City of Ryde Submission

85-97 Waterloo Road & 2 Banfield Road, Macquarie Park – Build to Rent SSD-52604208

Submission Date: 30 November 2023

Figure 1: Markup of Waterloo Road Precinct 2 Neighborhood Framework diagram (Base Source: Macquarie Park Structure Plan)

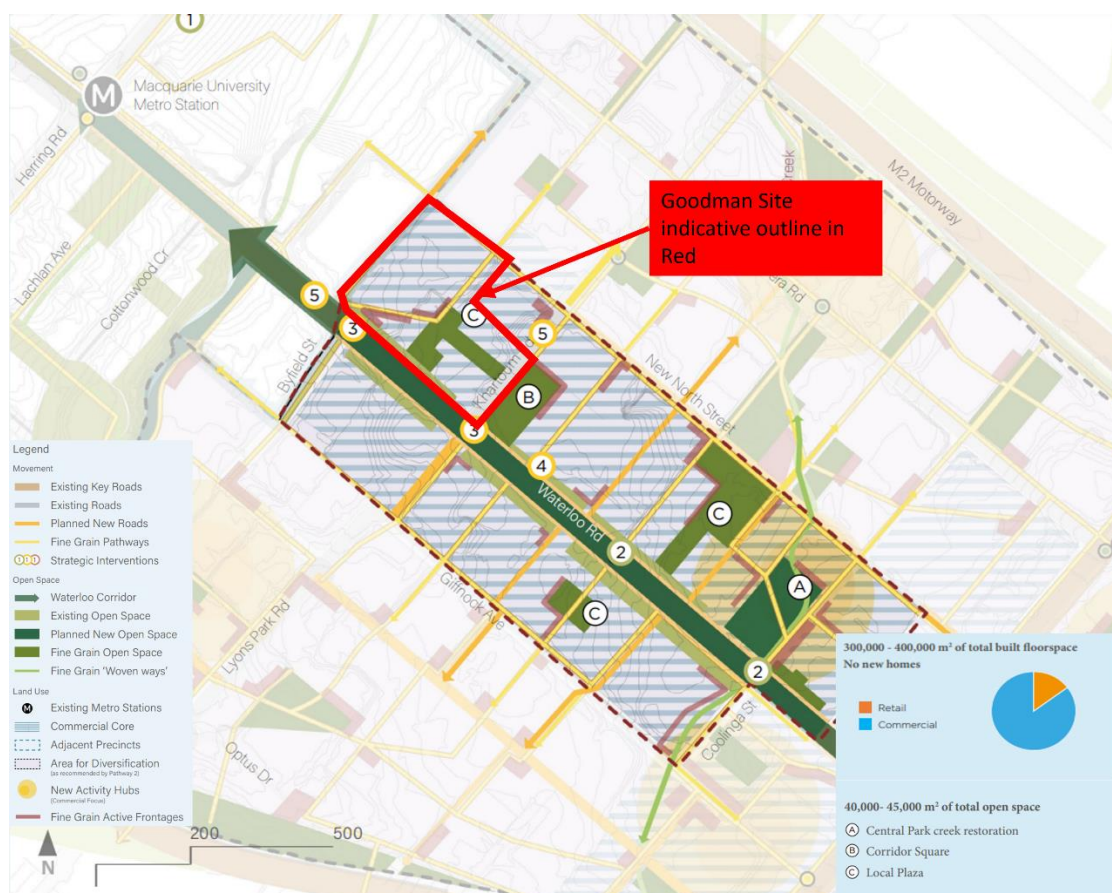
- The site is located within an area identified as Commercial Core in the Waterloo Park Precinct (Figure 1). The Place Strategy envisioned that Waterloo Park Precinct to be a commercial neighbourhood, there will be **no** new residential population within the Precinct. The Precinct will include 300,000 to 400,000 sqm of commercial and retail spaces with no new homes. The proposed 736 Built-to-rent dwellings are not consistent with the Place Strategy, as Built-to-rent is a type of residential development and will result in the increase of residential population in the Precinct.
- The Place Strategy outlines the intended land use outcomes for Precinct, two which states:

Figure 5: Exposed Basement Extract (Source: DKO)

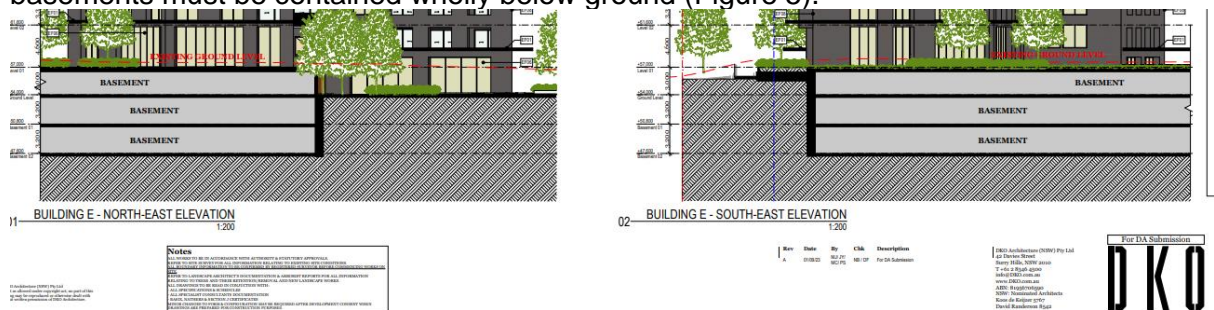
- Basements are proposed within the 10m setback which is not supported as it reduces Deep soil area. Additionally these basements are exposed above ground. This is not supported as basements must be contained wholly below ground (Figure 5).

Figure 6: Markup of Structure Plan for Precinct 2 (Base Source: Place Strategy and Masterplan Macquarie Park)

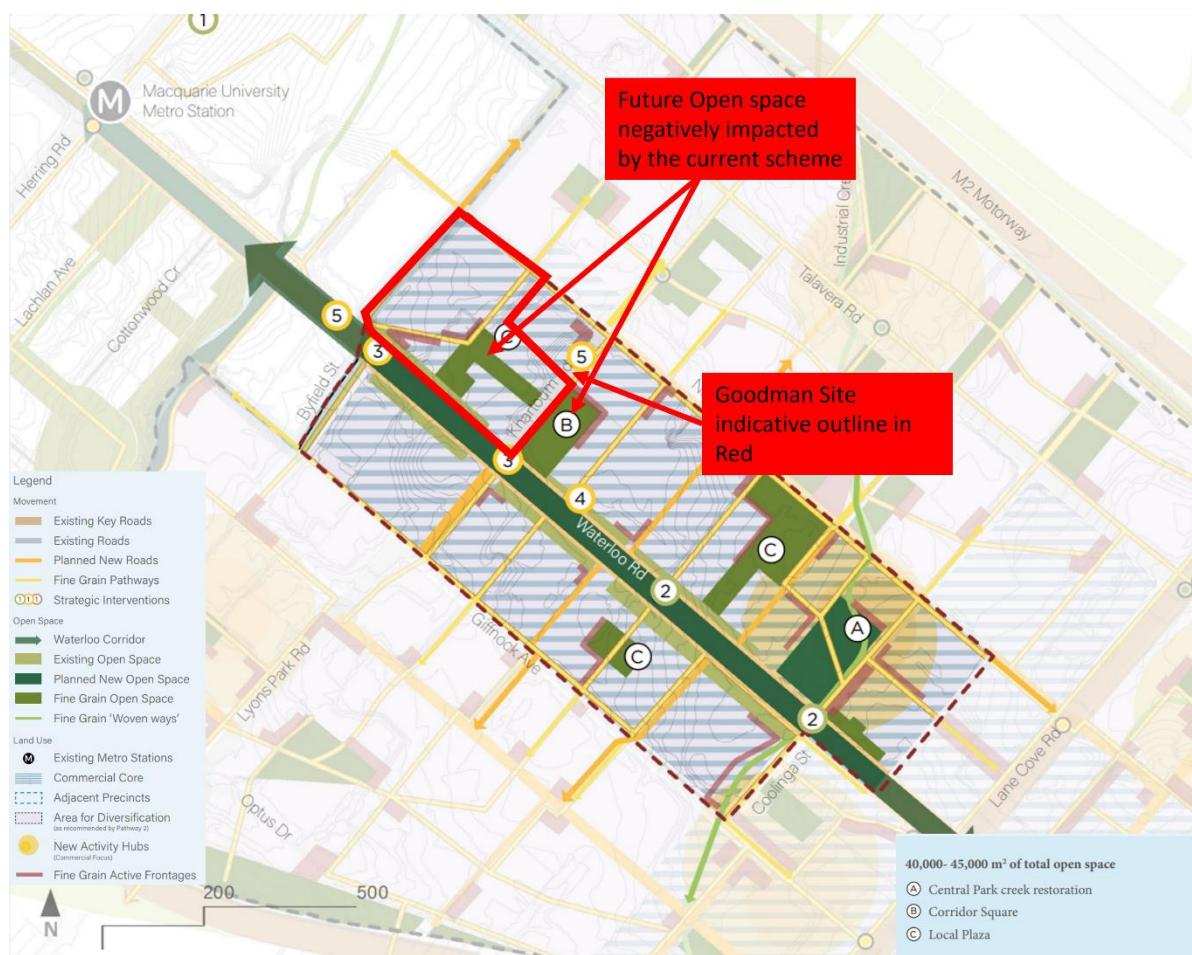
- Council notes the impact of the buildings design on the mixed-use plaza outlined in the Place Strategy. The current built form outcome severely compromises sunlight and aspect to the future open space (Figure 6). Of particular importance is the design criteria that requires sunlight protection to this area as follows:
 - *Open spaces are to have solar protection between 10am-2pm on the winter solstice.*

The submitted EIS provides rationale as to why severely compromising this solar access is acceptable, however Council does not accept this, as an improved design outcome on the site, could ensure amenity is retained for this important open space. The suggestion that little weight should be given to this is inappropriate. Part of the consistency test required by Clause 35 of the EPAR 2021, would be consideration of this control. In this regard, the open space is **NOT** demonstrated to have solar protection. Council does not accept the impact to this space when a more considered design approach could occur to ensure the retention and protection of solar amenity to this space.

Figure 8: Figure 7 from Appendix 0 (Source: RWDI)

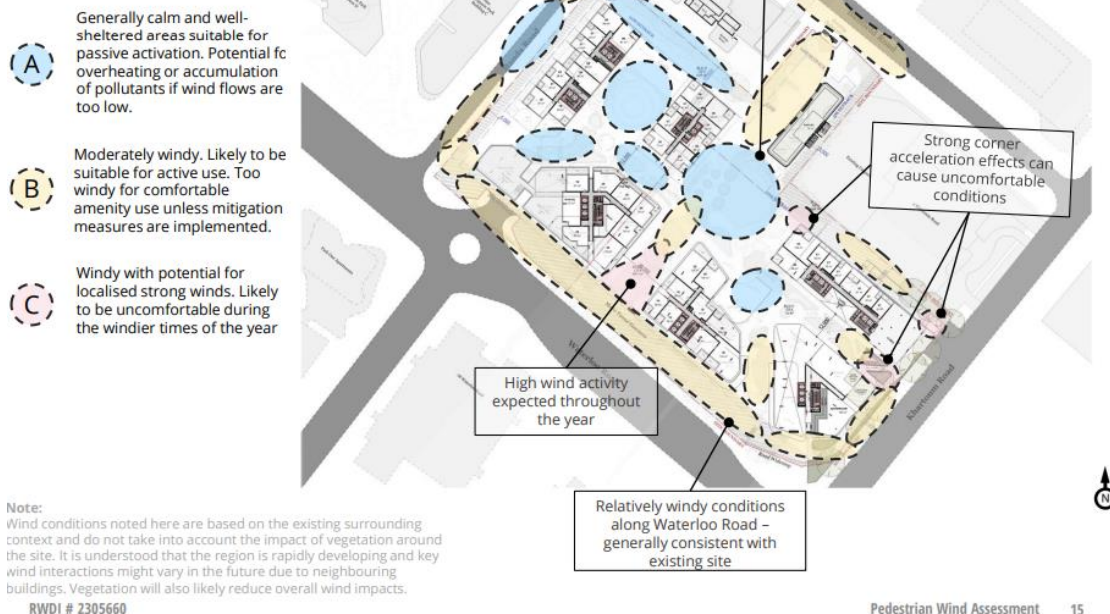
- Appendix O - Pedestrian Wind Environment Assessment outlines that there will be significant wind impact throughout the entire development, with majority of areas being too windy for comfortable usage. This is particularly evident as the locations proposed for open space and site links are a high wind category (Figure 8).
- These areas are likely to be used less frequently, and not serve its intended public benefit. Furthermore the area of high wind is the proposed active frontage, as such Council raises concerns with the amenity and usability of this space given the associated wind impact. The wind impact in this location is not supported by Council and reconsideration of this area is needed to ensure the development can response to appropriate wind considerations.

Figure 9: Mark up of Building E North Elevation (Source: DKO)

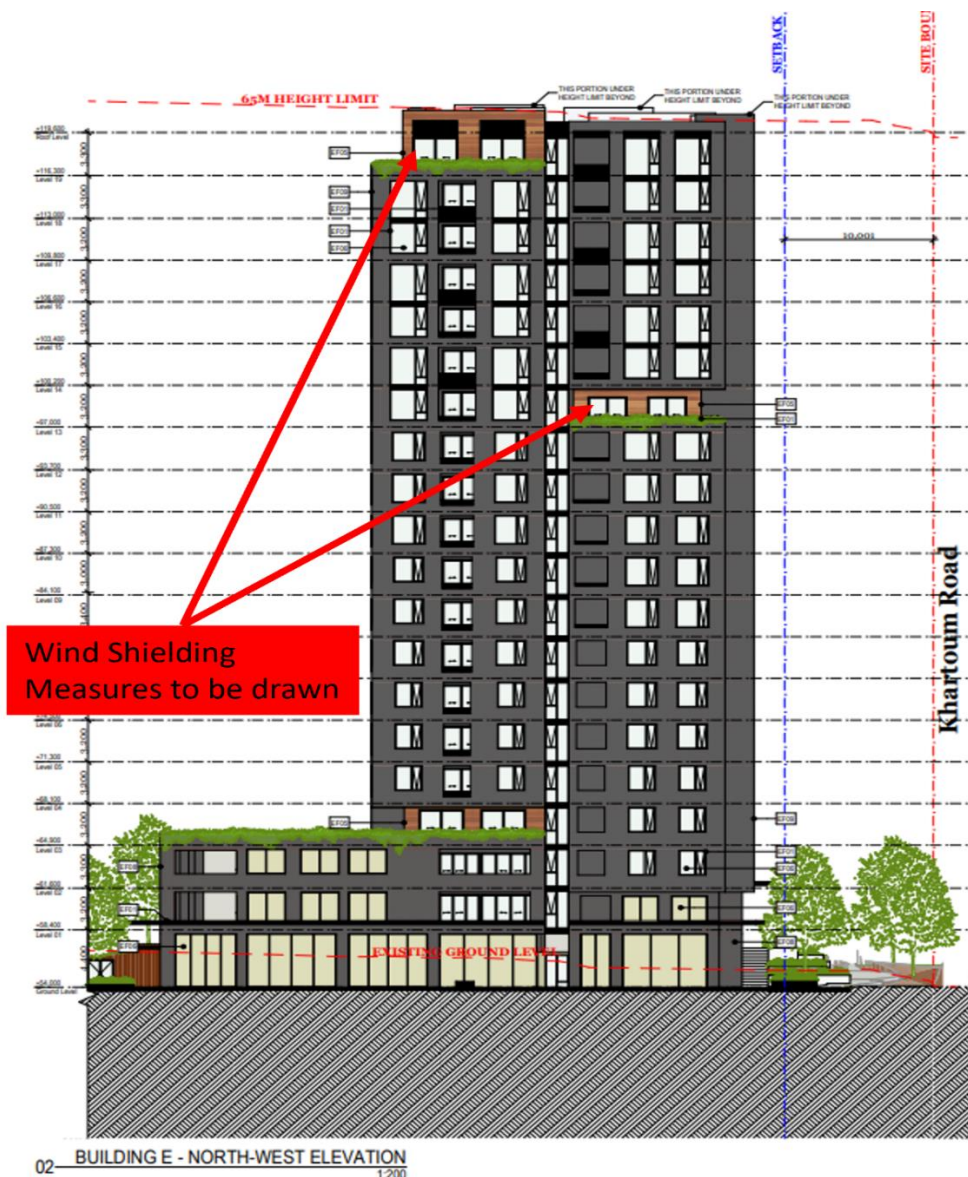
- The architectural drawings submitted with the application have not drawn in the preliminary recommendations (Figure 9). Given the associated impact of reduced amenity on these dwellings, Council requests that the architectural drawings be revised to consider the design advice in Appendix 0 and any revised assessment.

- Council notes that the preliminary wind assessment includes recommendations for screening and full height screening starting from 1.5m. this screening would then become included in the definition of GFA, therefore must be included in any amended architectural plan set. These inclusions into GFA would further exacerbate the GFA exceedance on the site, acting as a prohibition per clause 6.9 of the RLEP which the applicant seeks to benefit from.

- The Architectural design is to reflect the required recommendations (and any further mitigation measures, subject to the updated assessment). Amended plans are required.
- The Applicant is to include the required recommendations into their GFA and provide an updated GFA Schedule. This may require redesign and reduction of massing to stay within the incentive provision under clause 6.9 of the Ryde Local Environmental Plan 2014 (RLEP) maximum.

Figure 10: Markup of stormwater plan

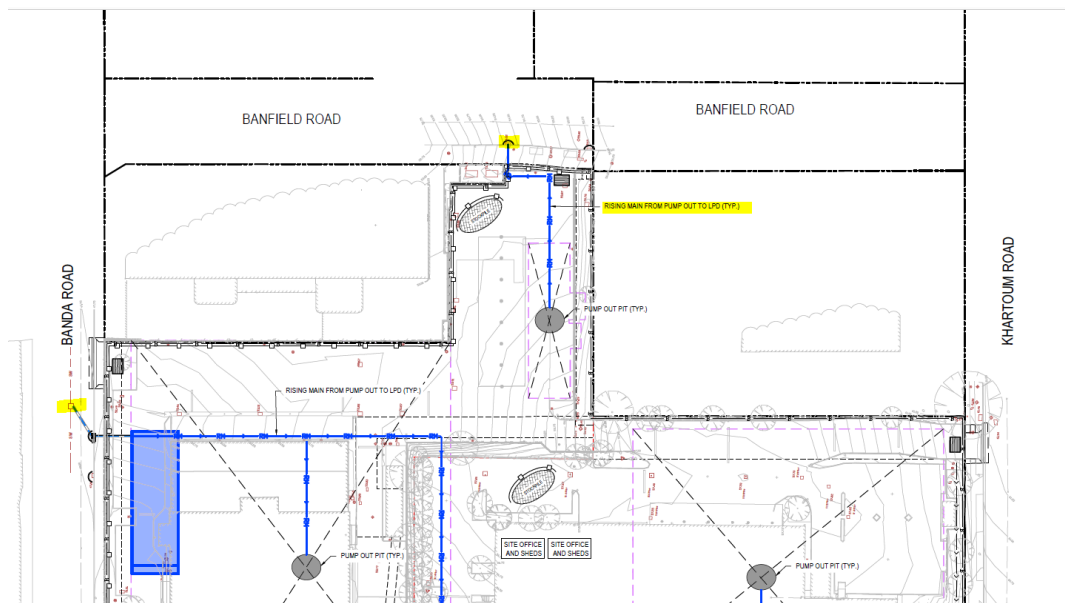
- The provided stormwater plans are generally very basic and do not provide any site levels, any surface drainage system and simply detail the onsite detention system and point of discharge. The following concerns are present.
 - There is insufficient detail to determine as to whether the surface drainage system caters for a failure mode (surcharge in the event of blockage) for the entire development. The plans must be updated showing surface inlet pits, invert levels, surface levels and grades over the site.

- Civil drawings (Revision A) prepared by at & I Pty Ltd dated 08 September 2023 to be modified and reflect below:
- Details of the connection to Council pits shall be included in the Stormwater Management Plan.
- Existing Council drainage infrastructure details including, diameter, etc. shall be shown on the plans.

Note: Please use Council asset numbers. Ensure the Council pit, which is being connected to, is indicated on the plans with Council pit numbering.

Figure 11: Extract from Ryde Maps

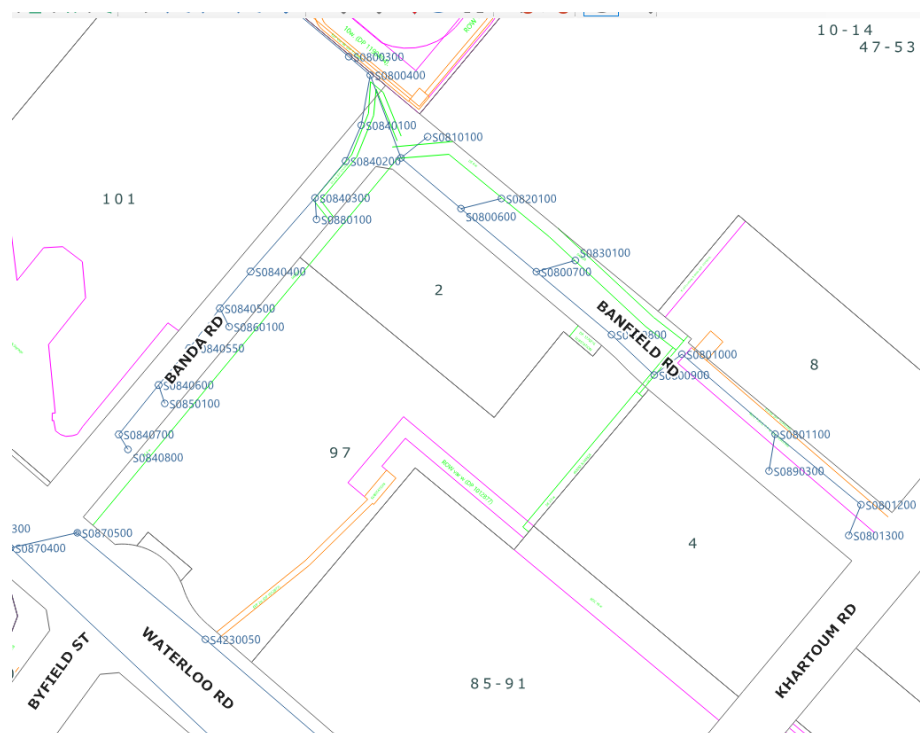
- Detailed survey plan to be provided showing the stormwater infrastructures and easement within the property. Physical location of the Council stormwater pipe, by non-destructive method is required, to update the survey plan with the exact position of the pipe, depth, invert level, etc.
- As highlighted below there is an existing stormwater pipe and easement within the property which is not shown on the plans. Please note that no encroachment to Council easement is allowed.
- The horizontal clearance from the proposed development to the existing pipe to be shown on the plan. Any development must be proposed at least 1m away from the existing outermost part of the Council pipe.

Figure 15: Markup of Precinct 2 Structure Plan (Base Source: Macquarie Park Corridor Masterplan)

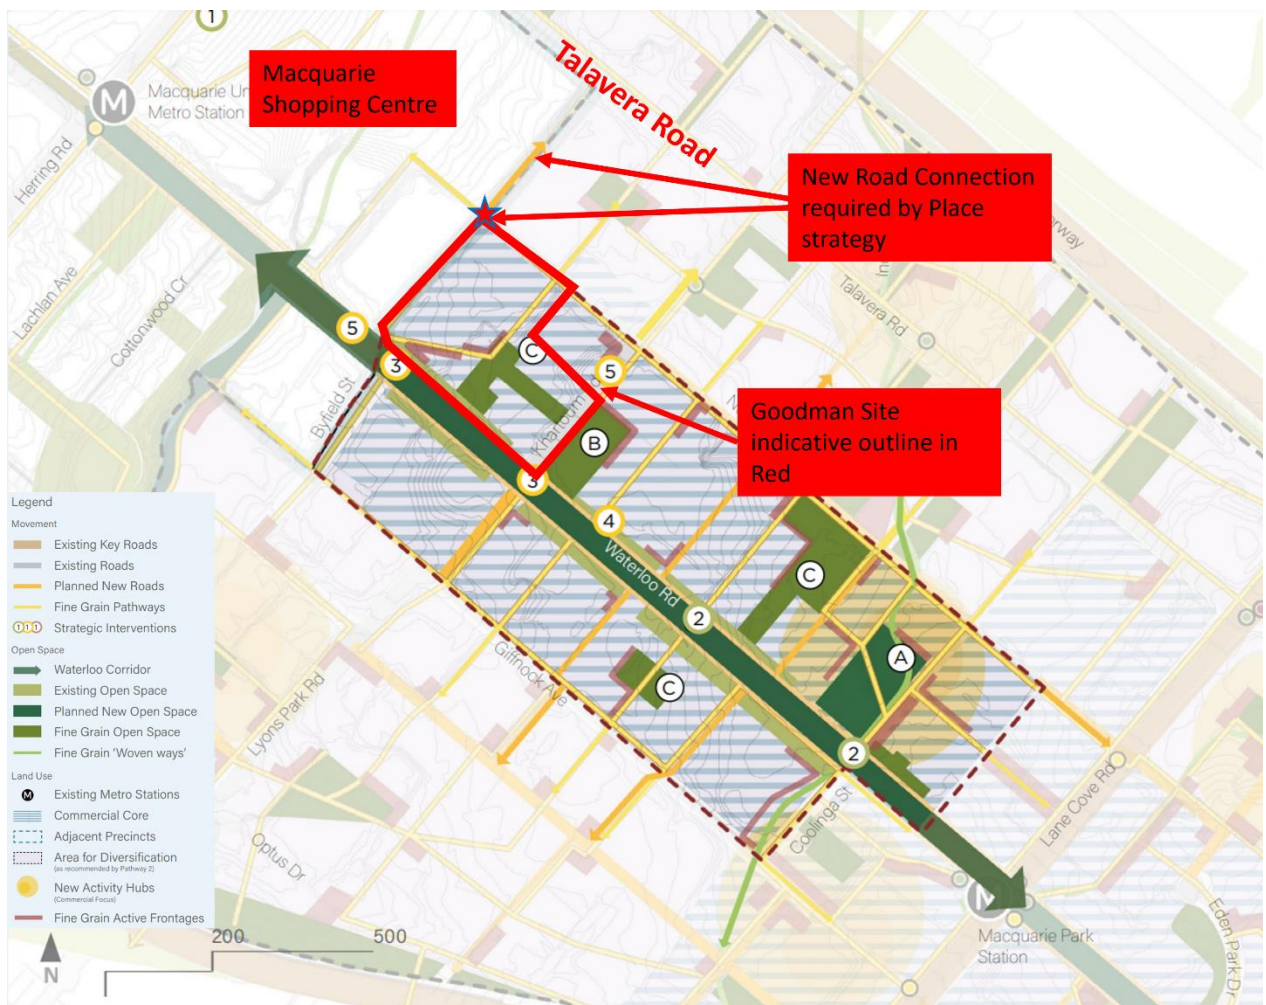
- The intersections of Waterloo Road/Khartoum Road and Waterloo Road and Byfield Street will need to be upgraded to traffic signal control along with other road geometry improvements to sustainably support the future development generated by the SSD. This requirement has been specified in DPE's Stage 1 Rezoning Proposal for Macquarie Park as well as a number of other technical planning documentation (e.g. City of Ryde Integrated Transport Strategy 2041).

- The intersection of Banda Road/Banfield Road is currently not connected with Macquarie Shopping Centre side, which is a major issues in developing a fine-grained road network in Macquarie Park, particularly as its outlined to be connected in the Place Strategy and Macquarie Park Masterplan (Figure 15). The applicant will need to liaise with the relevant stakeholder (AMP Capital) to construct the intersection of Banda Road/Banfield Road to be a four-way intersection, which would reduce the impacts of the site-generated traffic on local road network.
